Joseph M. Farley Nuclear Plant – Units 1 and 2
Response to Request for Additional Information Related to License Amendment Request
to Revise Technical Specification 5.5.17, “Containment Leakage Rate Testing Program” to
Increase Calculated Peak Containment Pressure

**Response to Request for Additional Information Related to License
Amendment Request to Revise Technical Specification 5.5.17,
“Containment Leakage Rate Testing Program” to Increase Calculated Peak
Containment Pressure**

REQUEST FOR ADDITIONAL INFORMATION
REGARDING CHANGES TO TECHNICAL SPECIFICATION 5.5.17 TO INCREASE
CALCULATED PEAK CONTAINMENT PRESSURE
EPID: L-2021-LLA-0229
LICENSE AMENDMENT REQUEST
JOSEPH M. FARLEY NUCLEAR PLANT, UNITS 1 AND 2
SOUTHERN NUCLEAR OPERATING COMPANY
DOCKET NOS. 50-348 AND 50-364

Figure RAI 1-1: Containment Pressure Comparison

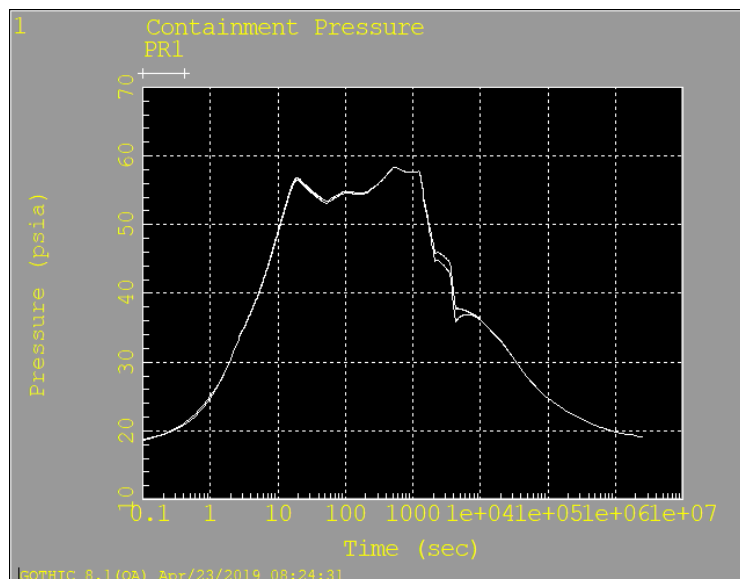
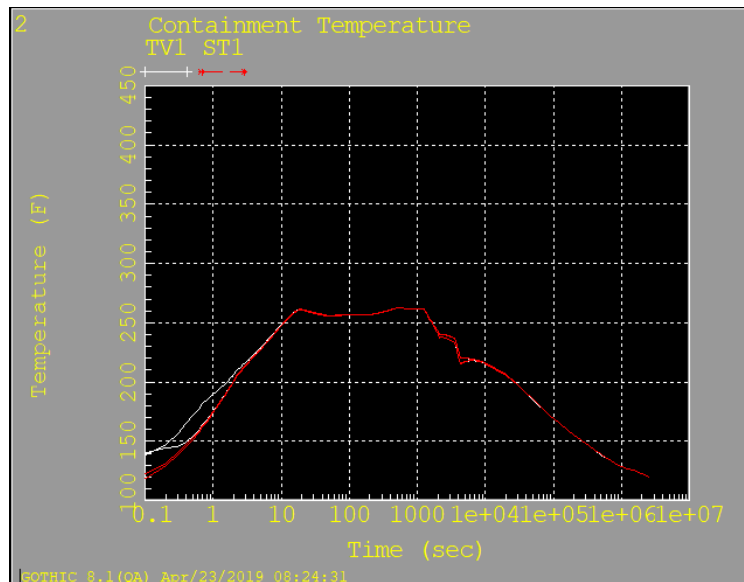
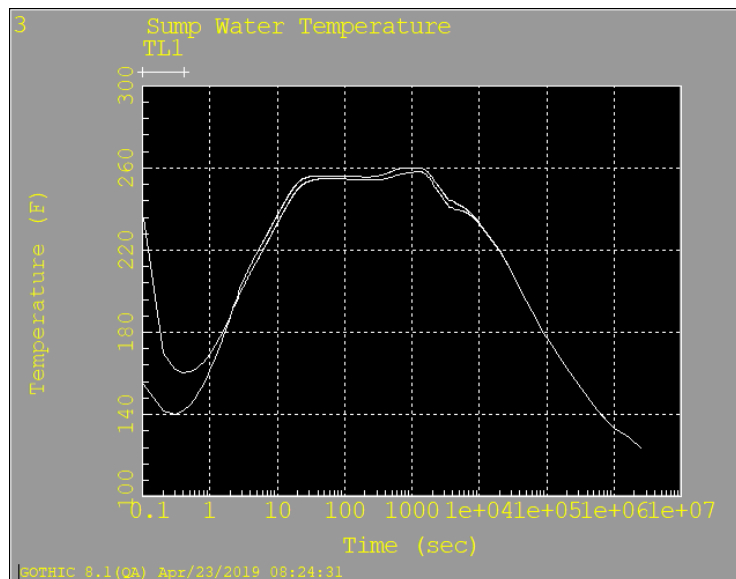
In Section 3.4 of the enclosure to the LAR, the licensee states that containment pressure analyses to determine the limiting LOCA were performed using Version 8.1 of the GOTHIC computer program. The NRC notes that Version 6.0 of GOTHIC code was used in the analysis of record (AOR) as described in the FNP Final Safety Analysis Report (FSAR), Section 6.2. In Section 3.4 of the enclosure to the LAR, the licensee states that "[t]he change in code version does not result in a numerically significant departure from the previous analysis and does not yield a benefit to peak pressure and temperature results."

The AOR and the revised analysis performed in support of this LAR do not utilize the same version of GOTHIC. Since GOTHIC is not an NRC-approved code but is an accepted code for containment response analysis for FNP, the NRC staff requests that the licensee provide data

to document that a verification analysis was performed to justify the assertion that the change in version does not result in a numerically significant departure from the previous analysis. The NRC staff requests that the licensee provide comparison results between the two versions of the GOTHIC code. For example, the licensee could provide a comparison of curves for the pressure and temperature response of the containment for the Double-Ended Hot Leg (DEHL) and Double-Ended Pump Suction (DEPS) cases documented in Figures 1 through 4 in Section 3.4.1 of the enclosure to the LAR.

SNC has performed a thorough benchmark between GOTHIC Versions 6.0 and 8.1 utilizing the most limiting case. The benchmark for LOCA was performed ahead of the Nuclear Safety Advisory Letter (NSAL) re-analysis using the analysis of record (AOR) double ended pump suction leg (minimum Safety Injection (SI)) case. The results are seen below in figures reproduced from the benchmark. The figures below were produced using the GOTHIC compare feature and include two traces for each variable included in the graph – one from the 6.0 run and one from the 8.1 run. In addition to comparing the results between the two versions, all code changes made for each version between 6.0 and 8.1 were evaluated for any effect they may have on the results produced by the containment model.

None of the changes which impacted SNC's containment model yielded a numerically significant difference in the reported results. However, one of the code changes did impact the calculation of sump water temperature in the very beginning of the transient. The AOR did not model any initial liquid in the sump and therefore the 8.1 version model is calculating unreasonably high temperatures in the first half second of the transient. This can be alleviated by initializing the model with a small amount of liquid in the sump. This is discussed in Section 3.4 of the LAR as one of the changes SNC made to the containment model as part of the NSAL analysis.

Figure RAI 2-1: Sump Temperature (log function)

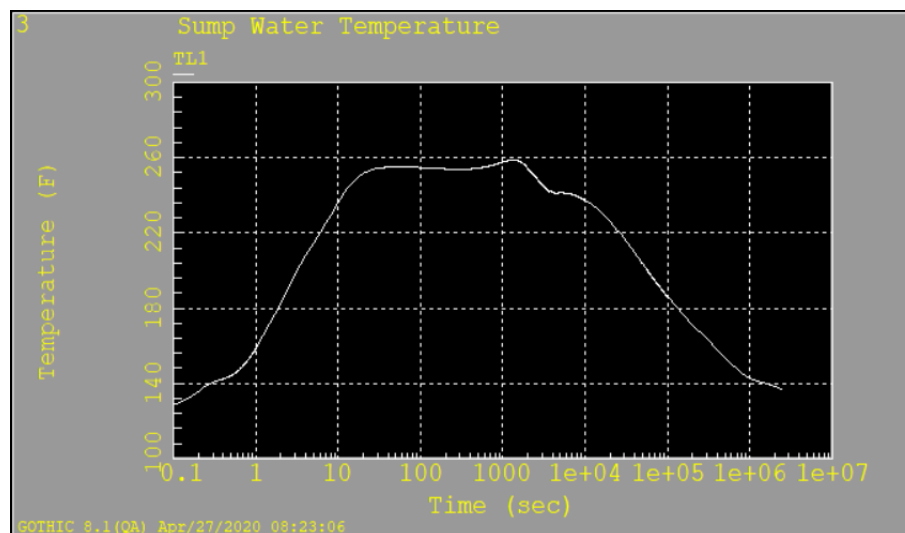
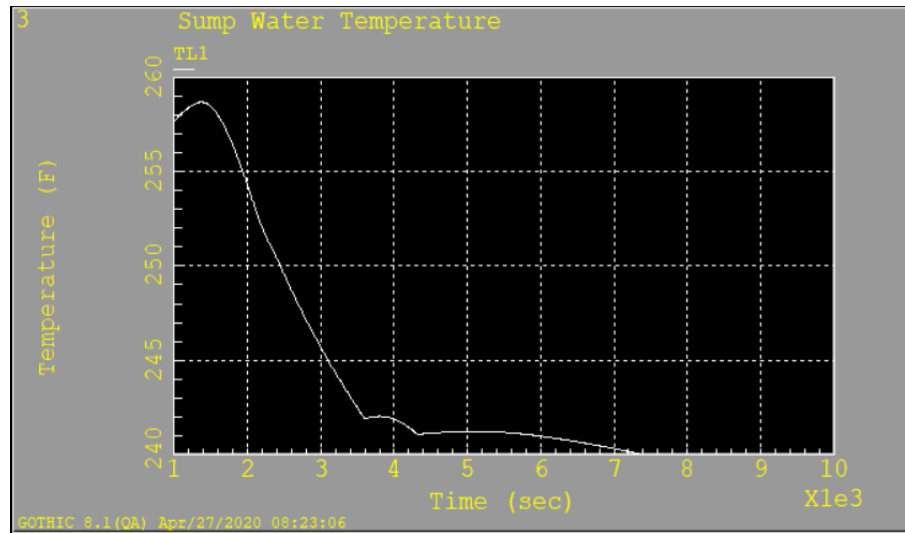
Section 6.2.1.3.6 of the FNP FSAR states that “[d]uring sump water recirculation, a third pressure peak occurs due to steam evolution from the reactor because of boiloff of the hotter core injection water.” The FSAR states that the maximum sump water temperature of 260 degrees Fahrenheit (°F) occurs at 1252 seconds (s). The NRC staff requests the licensee provide the following information to ensure acceptability of the containment heat removal system, consistent with requirements of GDC 38:

- (a) *Updated sump water temperature profile and the value of the peak water temperature during the LOCA recirculation phase.*

The peak sump temperature for the double ended pump suction (minimum SI) case is 259 °F at 1370 seconds. However, switchover to recirculation occurs at 2,139 seconds, which is after the calculated peak. Below, two graphs of the sump water temperature versus time are presented. The first graph shows the sump water temperature as a log function of time for the entire transient. The second graph is zoomed in to the area of the peak temperature and time of switchover to recirculation as a linear function of time. The highest temperature during recirculation occurs at the beginning of recirculation. This temperature is approximately 253 °F.
